Lindon City Planning Commission Staff Report

December 8, 2020

Item 4: Green Valley Major Subdivision Approval Approximately 600 North Main Street

Item 5: Minor Subdivision Approval. Mountain Tech South 6/7 - Approximately 2575 W. 400 N.

Plat "A"

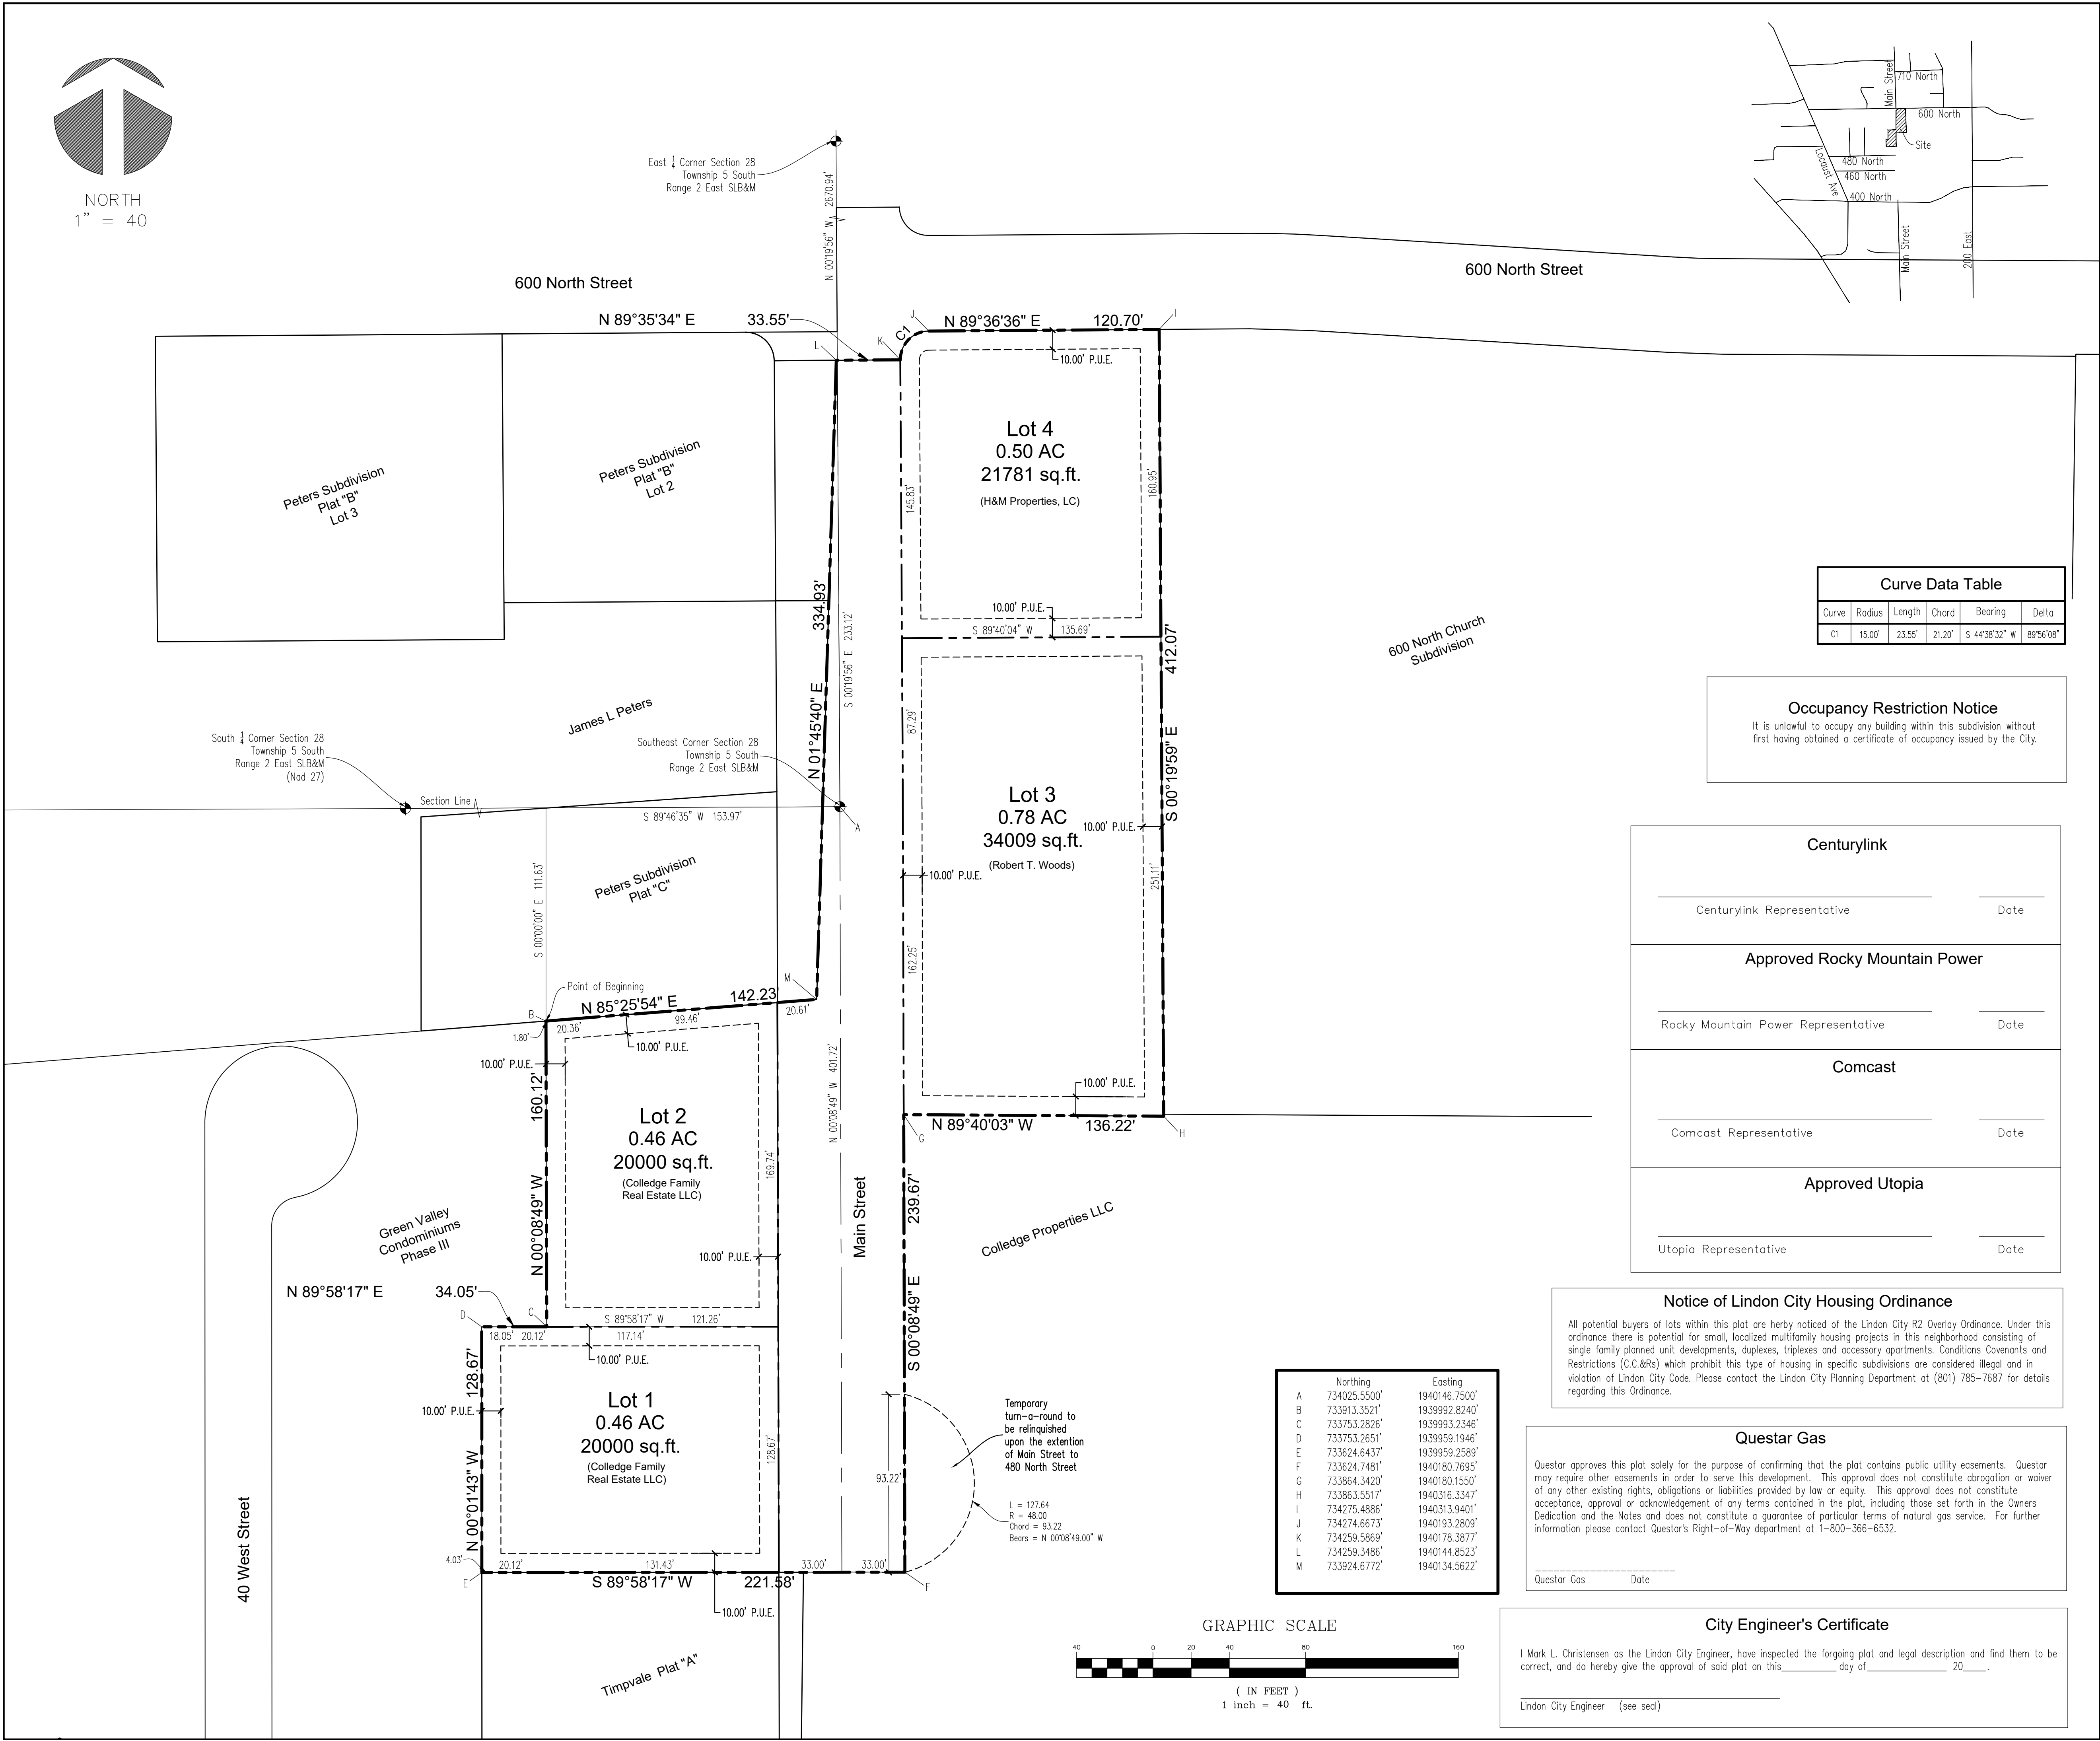
Required	Compliant
Minimum lot size: 20,000 square feet	Lots range in size from 20,000 square feet to 34,009 square feet

Required	Complaint
No single lot shall be divided by municipal or county boundary lines, roads, alleys, or other lots.	Yes
All residential lots shall front on a public street	Yes
Side lot lines shall be at right angles or radial to street lines.	Yes
The street layout shall conform to the master plan	Yes – Main Street will continue South in accordance with the street master plan. Main Street will end in a temporary cul-de-sac and not connect to 480 North as part of this subdivision.
Minimum right-of-way width for Minor streets	Yes – A 66 foot right of way is planned for the Main Street Cross Section.
Minor streets maximum grade: 12%	3.05%
Sidewalks, curbs and gutters shall be provided on both sides of all streets to be dedicated to the public	Yes – The addition to Main Street will include a 4-foot sidewalk on the West Side of the street and a 6-foot trail on the East Side of the street.
Easements shall follow rear and side lot lines whenever practical and shall have a minimum total width of 15 feet apportioned equally in abutting properties.	Yes

Underground utilities and piped sanitary sewerage shall be provided by the subdivider.	Yes
No lot shall be created which is more than three times as long as it is wide.	Yes
Street lights	Yes – An Esplanade Street Light will be installed on lot 2 along Main Street.

SITE PLAN

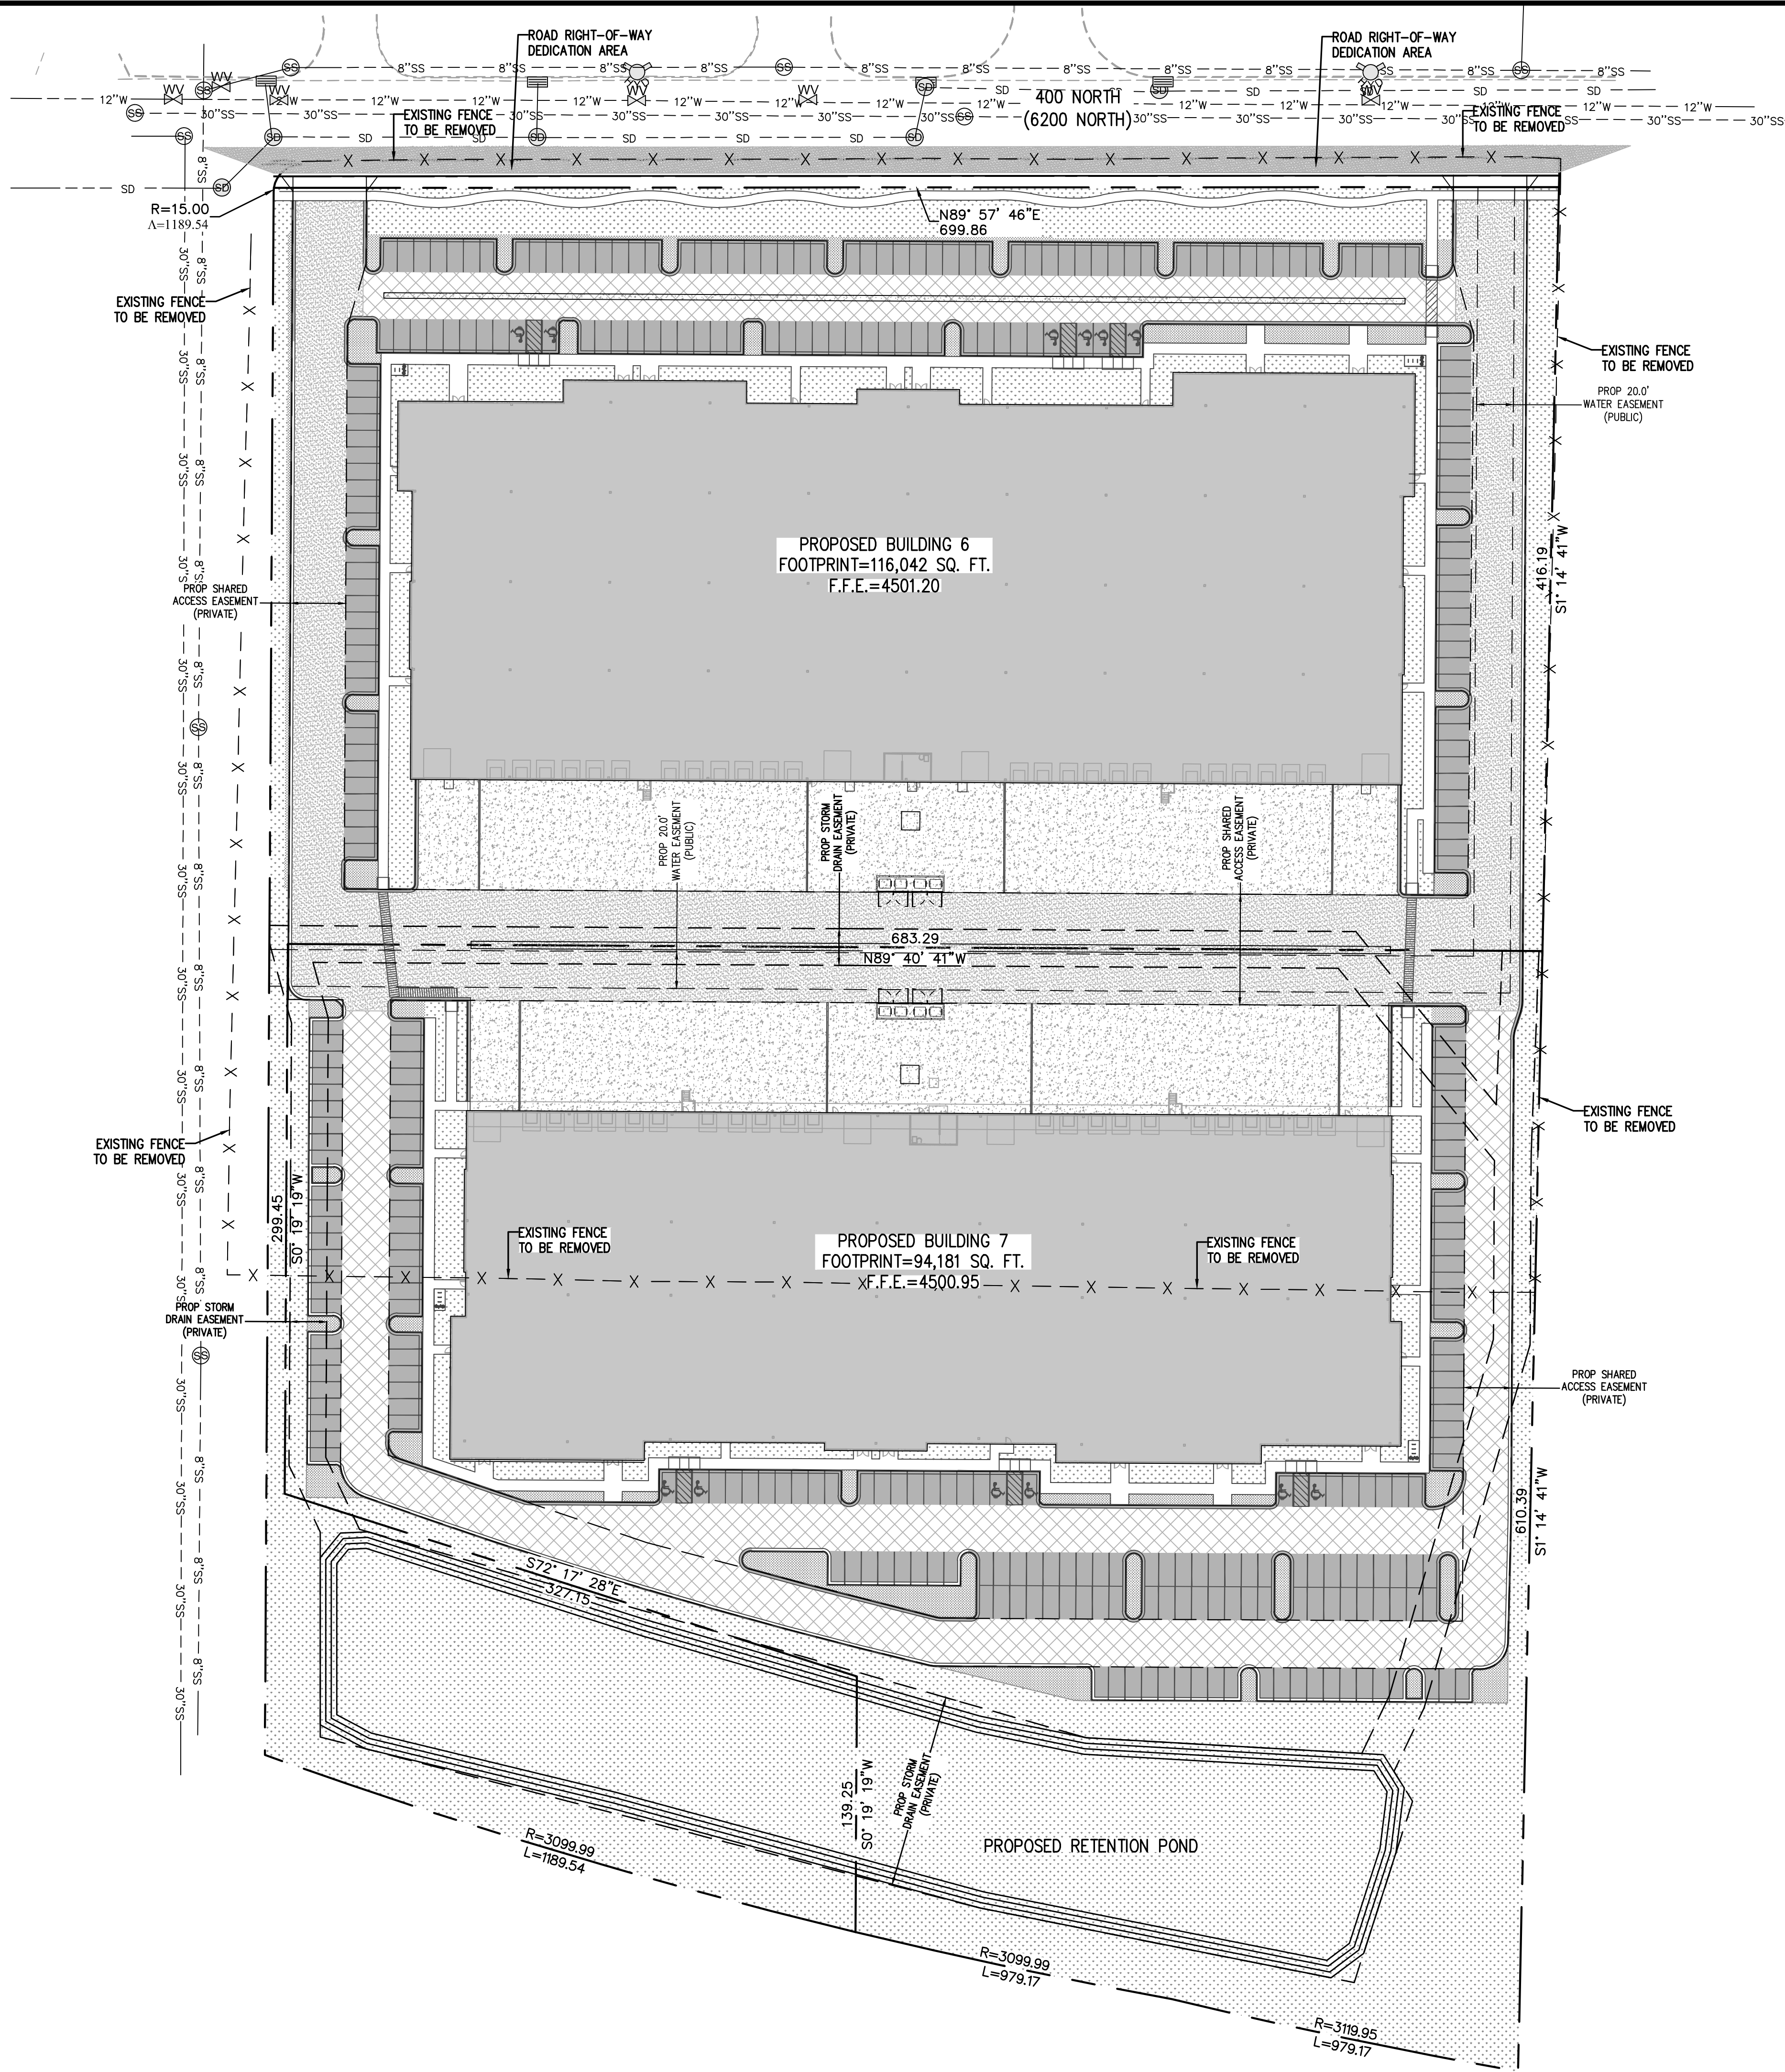
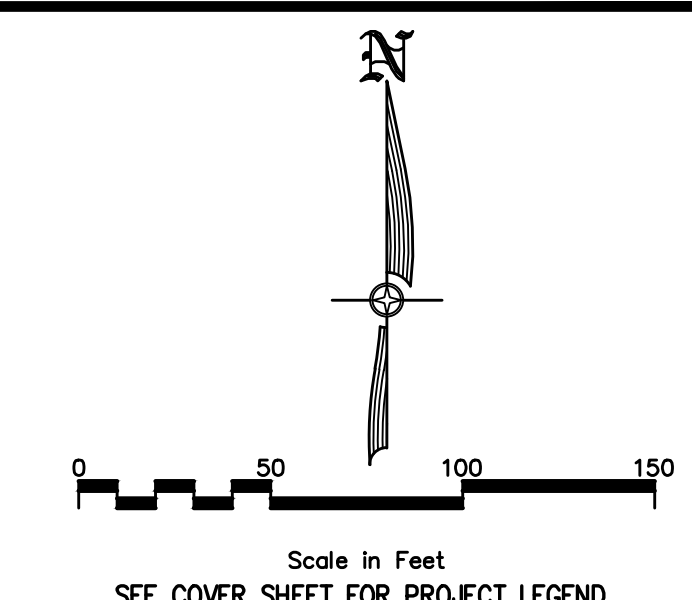
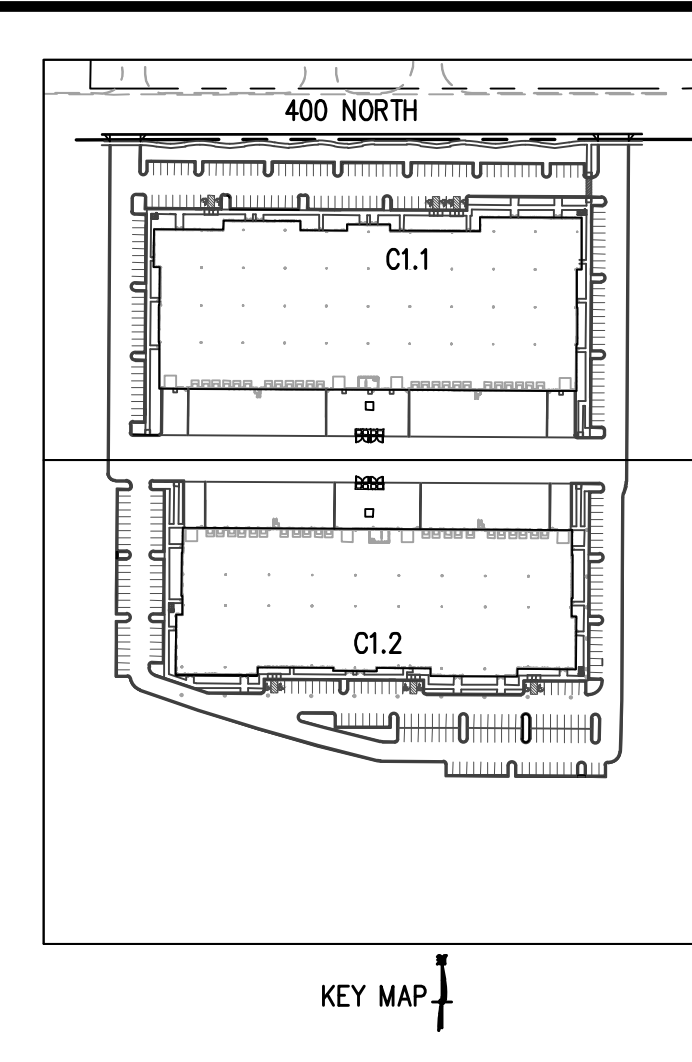
Required	Required/Provided
Office/Warehouse Building 1/Mtn Tech 6	
1 per 500 sq. ft. of warehouse floor area (106,042)	212/106
1 per 350 sq. ft. of office area (10,000)	29/29
Total stall required/provided	241/156 (ratio of 1 stall per 675 sq. ft.)
Bike Stalls	Compliant
Office/Warehouse Building 2/ Mtn Tech 7	
Required/Provided	
1 per 500 sq. ft. of warehouse floor area (83,517)	167/153
1 per 350 sq. ft. of office area (10,000)	29/29
Total stalls required/provided	196/182 (ratio of 1 stall per 550 sq. ft.)
Bike stalls	Compliant

The Lindon Planning Director and City Engineer have reviewed the proposed reduction in parking. The City parking code would require 437 parking stalls (241 for building 1 and 196 for building 2) to meet the code requirement. The application is proposing 338 stalls (156 for building 1 and 182 for building 2). With the attached parking study city staff feel comfortable recommending approval of the parking reduction to the planning commission. Staff feels that there would still be ample parking even if the use of the warehouse space changed to a manufacturing of other type of tenant. In the city parking code, the manufacturing parking rate is one stall per 750 square feet. There would be sufficient parking to meet this parking use. The only allowed use in the Regional Commercial zone that wouldn't meet the parking standard with the reduction are retail uses. However, even if the applicant constructed all of the parking it wouldn't meet a retail parking requirement.

Required Site Landscaping	Compliant
20 landscape strip along 400 N.	Yes
70% vegetation	Yes
Trees planted 30 foot on center	Yes

Required Interior Landscaping	Compliant
40 sq. ft. per parking stall 338*40 = 13,520	Yes
1 tree per 10 parking stalls	Yes
70% living material in landscaping	Yes

Setbacks - the proposed building meets the minimum setback of 30' from the front property line.
